**Errata, Comments, and Response to
Comments to the IS/MND for the
San Pedro Waterfront Enhancements
Project**

**ADP No.: 040511-067
State Clearinghouse Number: 2005061041**

April 2006

Figure 2-13 (Formerly 2-16)
Berth 78 Entrance Sign

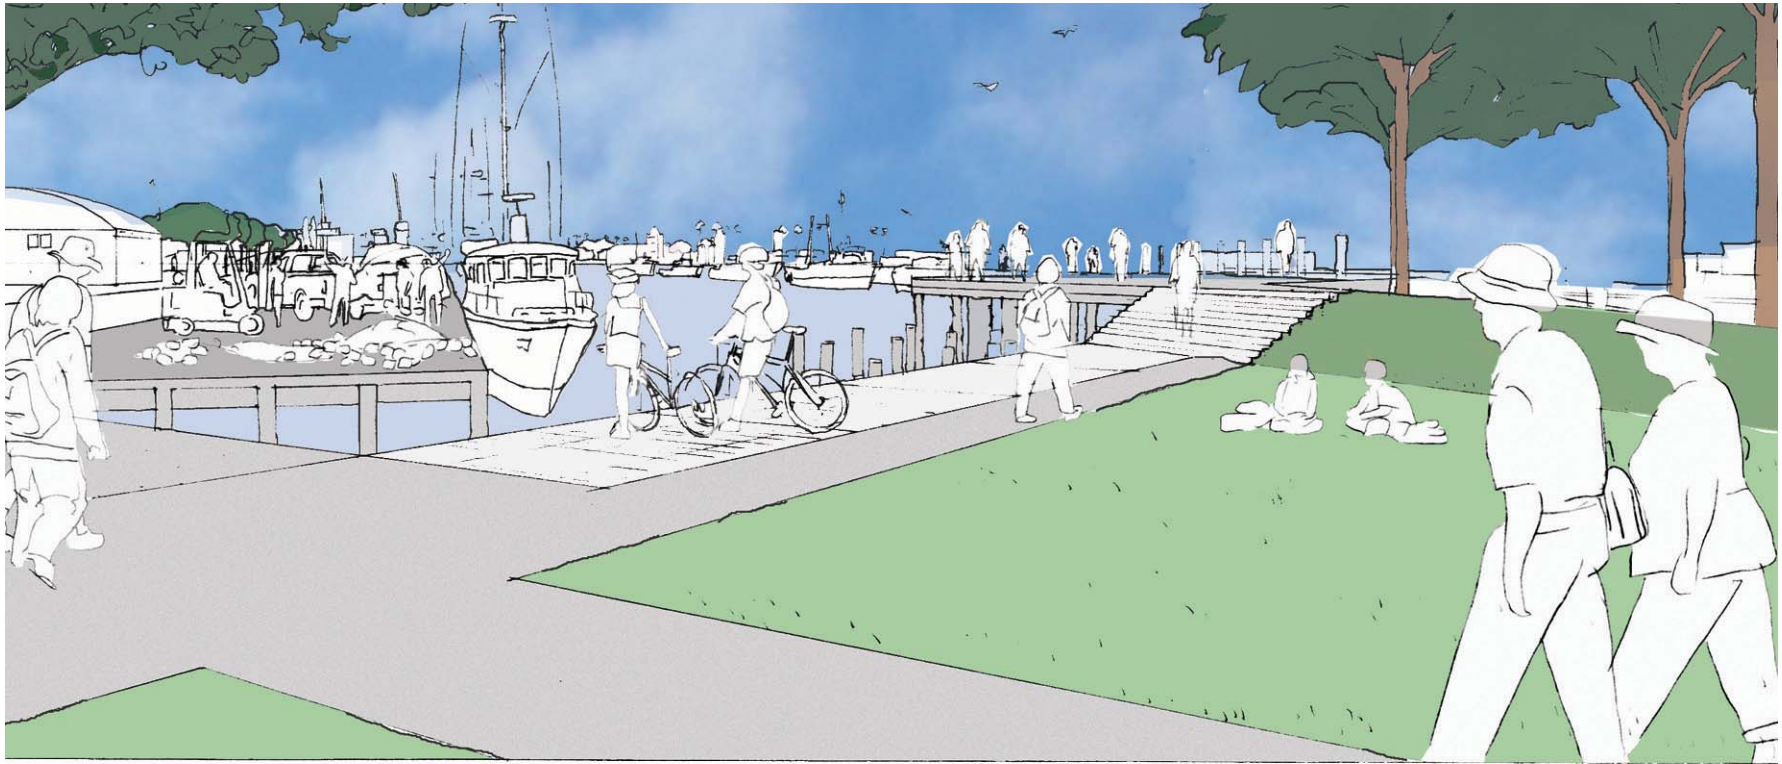
Two A berth identity signs, each approximately 20 feet tall, would announce and span the entrance to Berth 78. One The sign, which is shown in Figure 2-~~16~~13, would be located at the entrance to the Ports O' Call parking area, at the intersection of Sampson Way and the 13th Street extension. The second sign would be located at the foot of the 13th Street extension, along the Paseo. The signs would be lower than existing structures and are is intended to be a visual focal points to draw attention to the adjacent shops, restaurants, and waterfront.

The text was revised to reflect changes to the project, including the removal of the Berth 78 pier and mudflat elements, and to reflect that the Berth 78 sign has been downscaled. Signage will be a topic at the future public design meeting.]

**Figure 2-16 (Formerly 2-13, Revised)
Sampson Way and 22nd Street Parking**

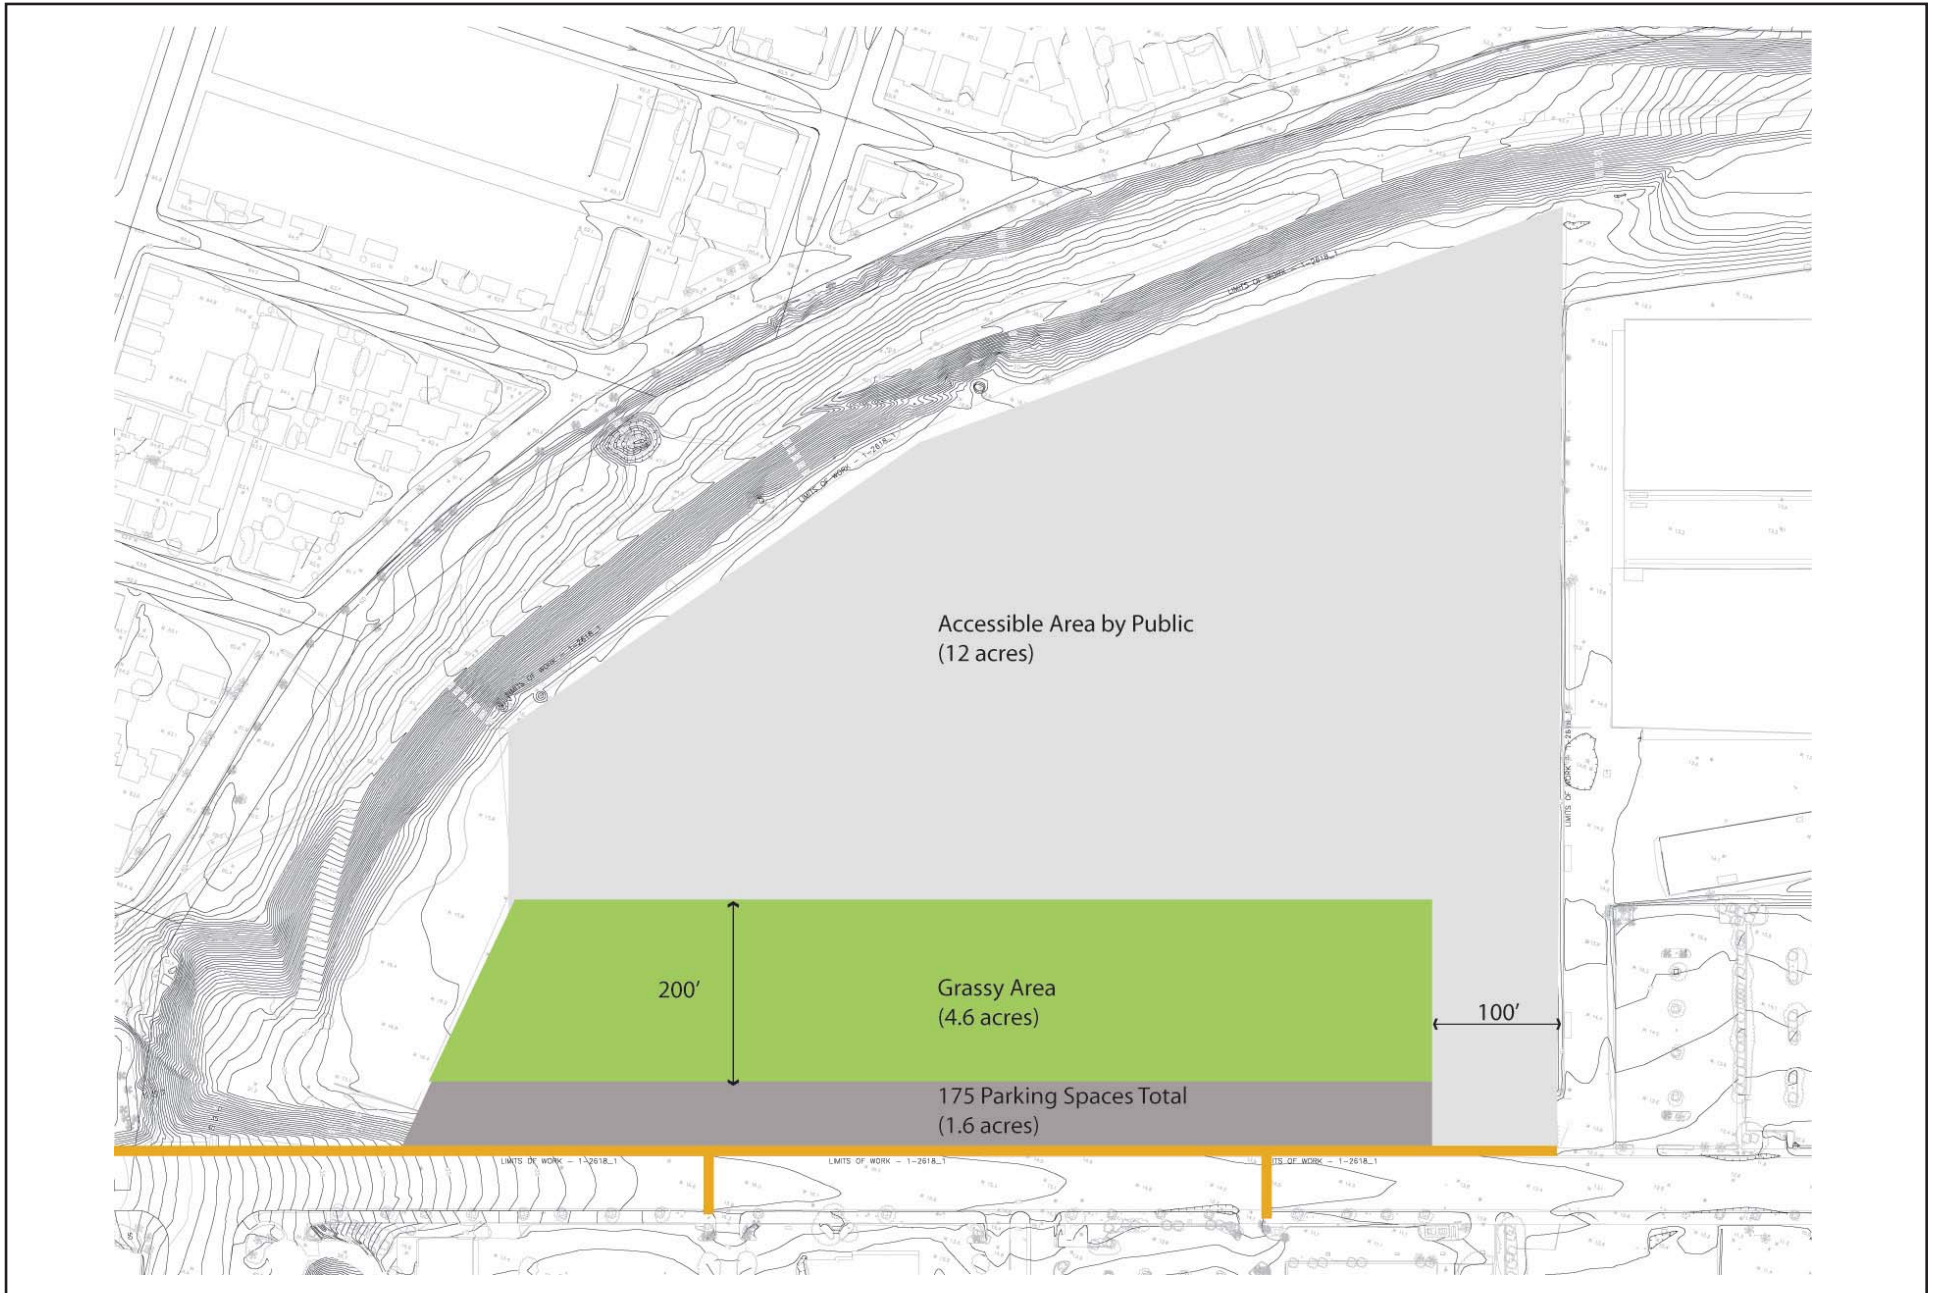
The paved parking spaces lost in Ports O'Call would be relocated to a currently dirt and gravel parking area at Sampson Way and 22nd Street that is used for event parking. The approximately 9.6-acre unimproved lot would be upgraded to provide 150 paved parking spaces (2.8 acres), with 6.8 acres of landscaping and gravel or other pervious material cover (See Figure 2-16). The existing non-paved spaces included in the parking area would continue to serve as available event parking (i.e. Lobster Fest). Additionally, two pedestrian rail crossings would be constructed over the tracks near Sampson Way to facilitate safe pedestrian passage from the parking area to the SP Slip.

This text has been added to provide more detail regarding the current use and proposed improvements to the parking area at Sampson Way and 22nd Street.]
